**PCN# 20161114000  
ADC32xx/34xx Product Family Design Change  
Information Only**

<b>PCN Number:</b>		20161114000		<b>PCN Date:</b>		Nov 15, 2016	
<b>Title:</b>		ADC32xx/34xx Product Family Design Change					
<b>Customer Contact:</b>		PCN Manager		<b>Dept:</b>		Quality Services	
<b>Proposed 1<sup>st</sup> Ship Date:</b>		Nov 15, 2016		<b>Estimated Sample Availability:</b>		Date provided at sample request	
<b>Change Type:</b>							
<input type="checkbox"/>	Assembly Site	<input type="checkbox"/>	Assembly Process	<input type="checkbox"/>	Assembly Materials		
<input checked="" type="checkbox"/>	Design	<input type="checkbox"/>	Electrical Specification	<input type="checkbox"/>	Mechanical Specification		
<input type="checkbox"/>	Test Site	<input type="checkbox"/>	Packing/Shipping/Labeling	<input type="checkbox"/>	Test Process		
<input type="checkbox"/>	Wafer Bump Site	<input type="checkbox"/>	Wafer Bump Material	<input type="checkbox"/>	Wafer Bump Process		
<input type="checkbox"/>	Wafer Fab Site	<input type="checkbox"/>	Wafer Fab Materials	<input type="checkbox"/>	Wafer Fab Process

Texas Instruments Incorporated is announcing an information only notification for a design change on t

Figure 1 Glitch on ADC reference voltage

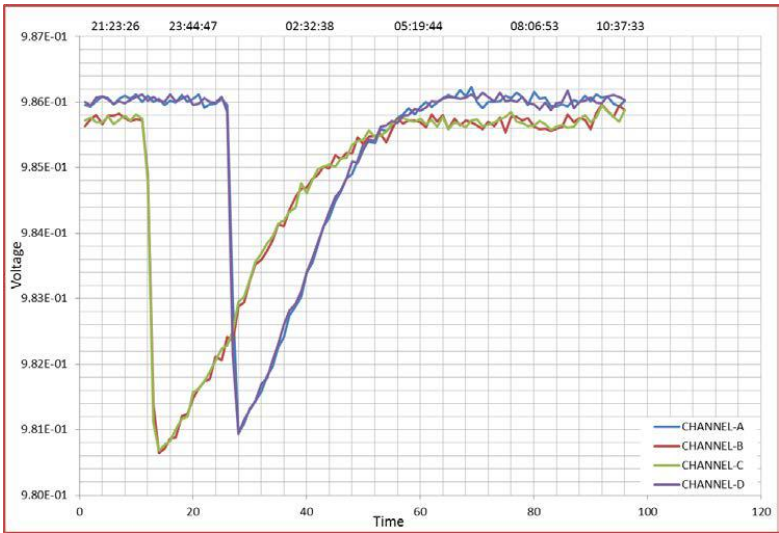
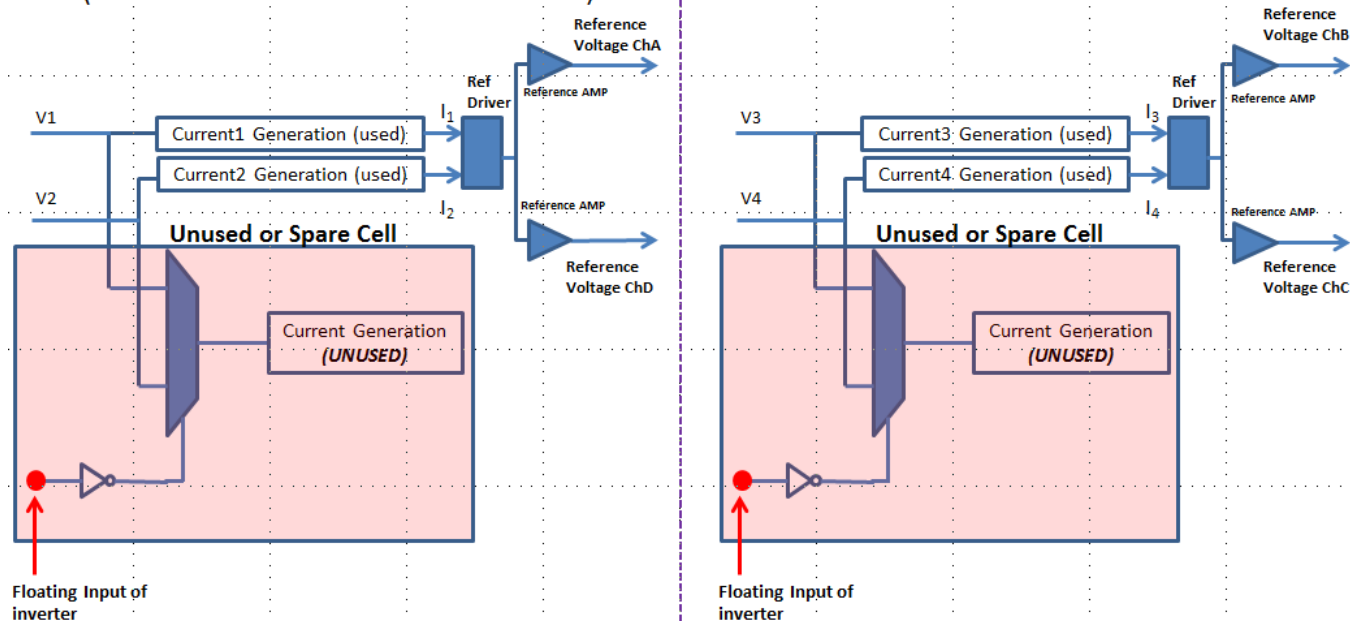
1. ADC’s gain error (1) shows a ‘glitch’ when a fresh device is tested.
  - a. For quad channel part (ADC34xx/34Jxx), channel A and D show the glitch together, while channel B and C show it together. For dual channel part (ADC32xx/32Jxx), glitch occurs at the same time for channel A and B.
  - b. When glitch occurs, the gain error increases by ~0.5%.
  - c. The glitch shows a very slow settling profile with a time constant of ‘hours’.
  - d. Once settled, the glitch doesn’t occur again, i.e. the glitch occur only once for a given device.
  - e. This issue doesn’t cause any impact on AC performance.
  - f. The issue affects only time-domain applications.
2. Lab test show that glitch in gain error is a result of glitch in ADC’s reference voltage as shown in figure 1

The floating gate of inverter in unused cell is connected to deterministic state (AVDD supply) in new Silicon. While it solves the problem, it doesn't impact any parameter (performance, power or timing) of device in any possible way since the unused cell is not used anywhere in design for any purpose.
